AS BUILT PLANS: 12.6.10

PLAN LINE 2

PROFILE LINE 2

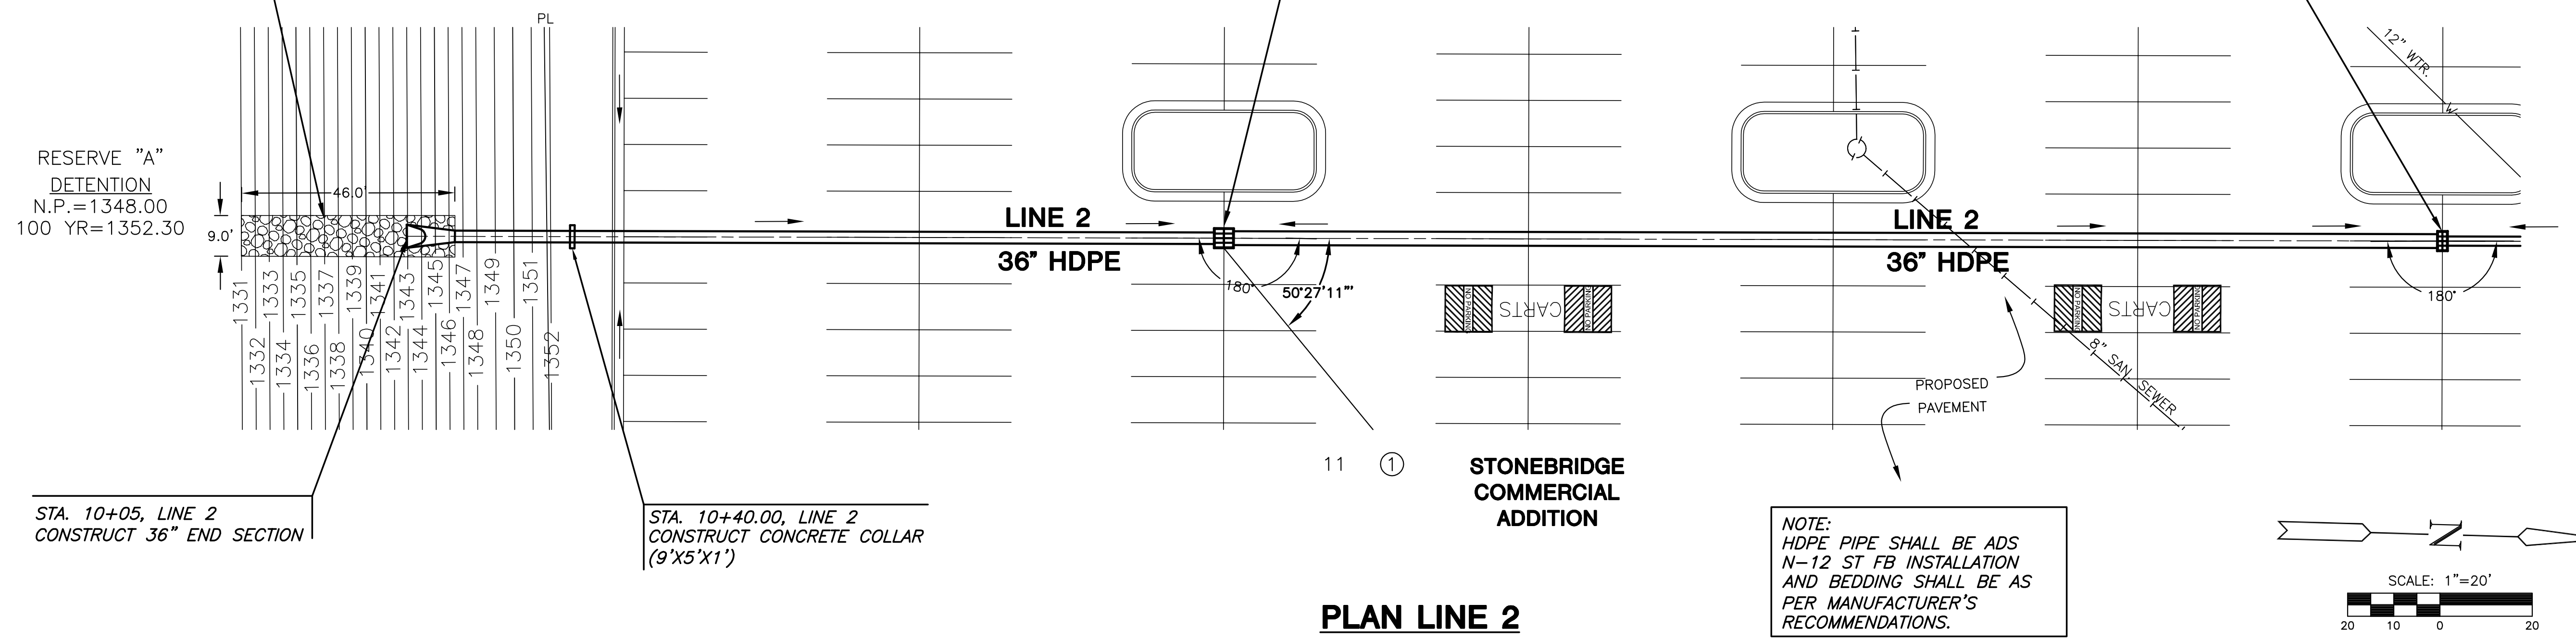
NOTE:
EROSION CONTROL ADD ALT.
INSTALL SCOUR STOP INSTEAD
OF RIP-RAP SEE SHEET 29

STA. 11+81.7, LINE 2
CONSTRUCT 2-DOUBLE DROP INLET
INLET TOP=+351.75-1351.79 A.B.
PROVIDE SEDIMENT BARRIER

STA. 14+45.7, LINE 2
CONSTRUCT DOUBLE DROP INLET
INLET TOP=+351.75-1351.72 A.B.
PROVIDE SEDIMENT BARRIER
